Parcel Map #02496  
PROJECT TYPE: David P. Church Subdivision SUPERVISOR DISTRICT #2

LOCATION: 1072 Mary Avenue APN: 054-210-078-000

**Parcel Map #02496  
Initial Study #22-0012  
David P. Church Subdivision**

**TENTATIVE PARCEL MAP**

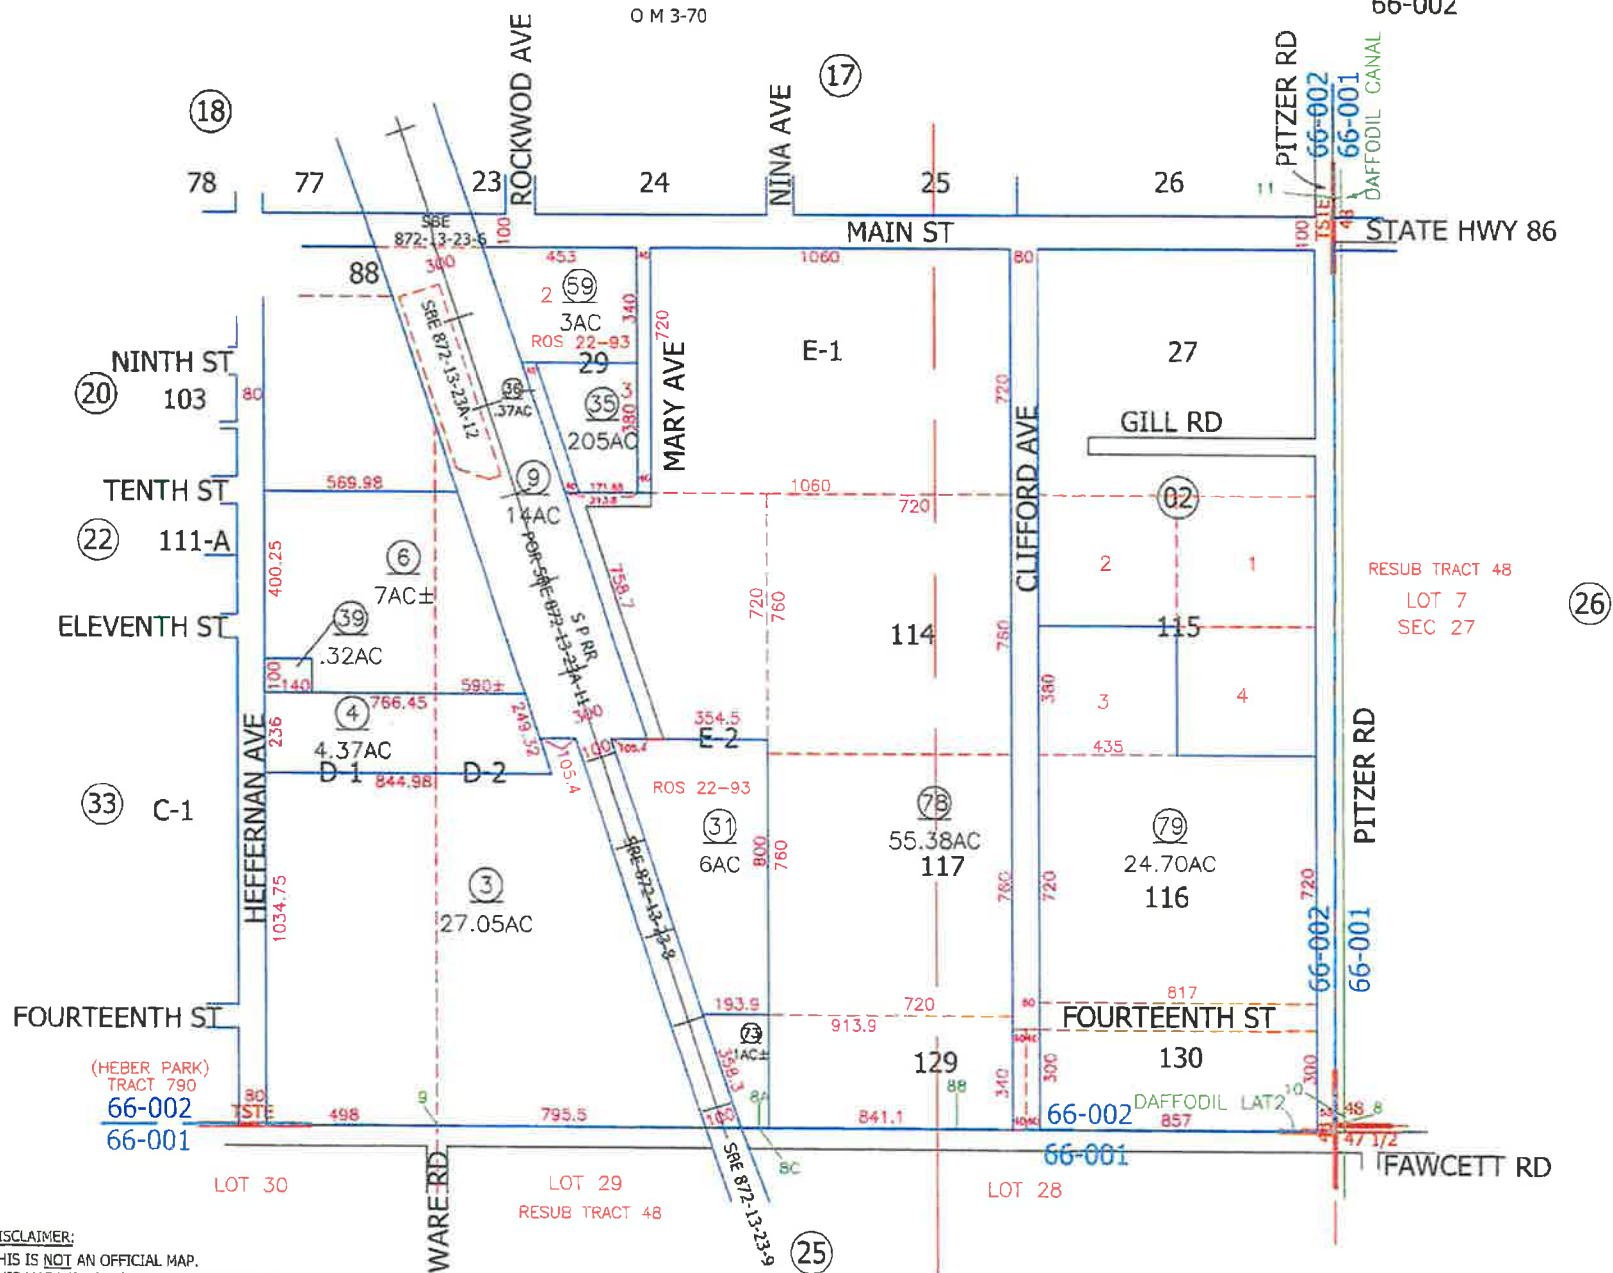
- The Minor Subdivision application identifies proposed Parcel 4 as receiving ingress and egress from Fawcett Road. Site inspection reveals insufficient width for safe vehicular ingress and egress. Both the primary and secondary points of access for proposed Parcel 4 shall be widened to provide minimum openings of thirty (30) feet in width between irrigation structures at Subdivider's expense prior to recordation of the parcel map. The Subdivider may defer widening of the access openings if security is provided by the Subdivider prior to approval of the parcel map.

- Street Improvements shall be required for Clifford Road, Fawcett Road, and Mary Avenue. Improvement Plan shall be submitted approved by this Department prior to recordation of the Parcel Map.

3. Should future development of proposed parcel #4 be for considered for industrial use and require site access from Fawcett Road, an IID crossing and encroachment permit will be required. When new crossings or modification to the existing crossings are needed, the applicant will be responsible for the cost of these improvements and IID will design and construct them.
